UN Regulation No. 16 (Safety-belts)

Proposal for the 09 series of amendments

Submitted by the experts from Japan*

The text reproduced below describes the new requirements for safety-belts of seat positions equipped with the lower ISOFIX anchorage. It is based on informal document GRSP-69-23 distributed during the sixty-ninth session of the Working Party on Passive Safety (GRSP). The modifications to the current text of the UN Regulation are marked in bold for new characters.

Figure 2

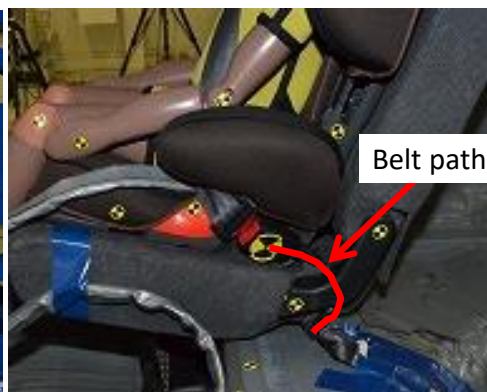
1. The strap's paths between the effective safety-belt anchorage and the buckle are normally straight like the test bench specified in UN Regulation No. 129 (Figure 1). However, the strap's paths between the effective belt-anchorage and the buckle of some vehicles in the market are not straight and are curved along the cushion (Figure 2).

2. When the strap's paths between the effective belt anchorage and the buckle are not straight, the occupants may move significantly forward during a frontal impact accident. If an occupant is seated in the booster seat attached by ISOFIX, there are cases in which the seatbelt slips up to the neck and in which submarining occurs (referred to in GRSP-69-24).

- "8.2.3. The requirement of the strap between the buckle and effective belt anchorage at seats equipped with ISOFIX lower anchorages."**
- 8.2.3.1. The difference between the actual strap length and the straight line distance between the effective belt anchorage and BP point for the buckle strap, according to paragraph 3.2. of Annex 17, Appendix 1, should be 50 mm or less."**

Figure 3
Relation between the Amount of Slack of the Buckle Strap and Dummy 3ms Chest Maximum Acceleration

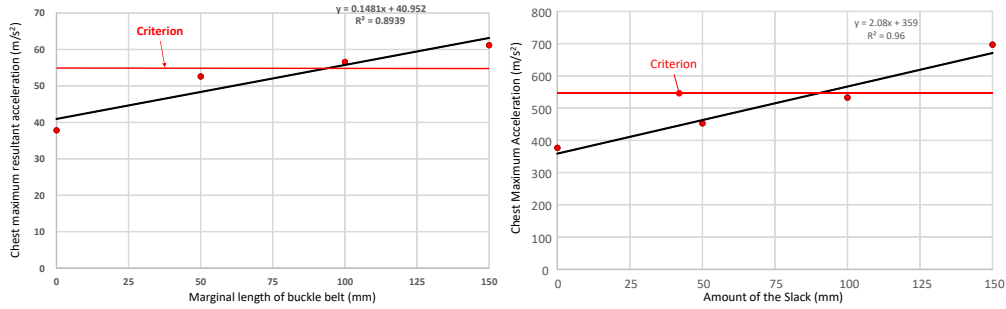
These phenomena would increase the risk of injuries to the neck and abdomen of a child occupant. In addition, the dummy chest injury increases. Figure 3 shows the relation between the amount of slack of the buckle strap and dummy 3 ms chest maximum acceleration for two types of CRS. When the slack of the buckle belt was over [50] mm, the chest maximum acceleration approached UN Regulation No. 129 criteria in one CRS. When the slack of the buckle belt was over [80] mm, the chest maximum acceleration exceeded the above-mentioned criteria.

3. The slack of the buckle belt makes the passenger’s excursion larger, negatively affecting the safety of the occupant.
4. Therefore, we propose to limit the slack of the buckle-belt in seating positions equipped with ISOFIX lower anchorages.
5. These amendments prevent the phenomena of the safety-belt slipping up to the neck and of submarining.
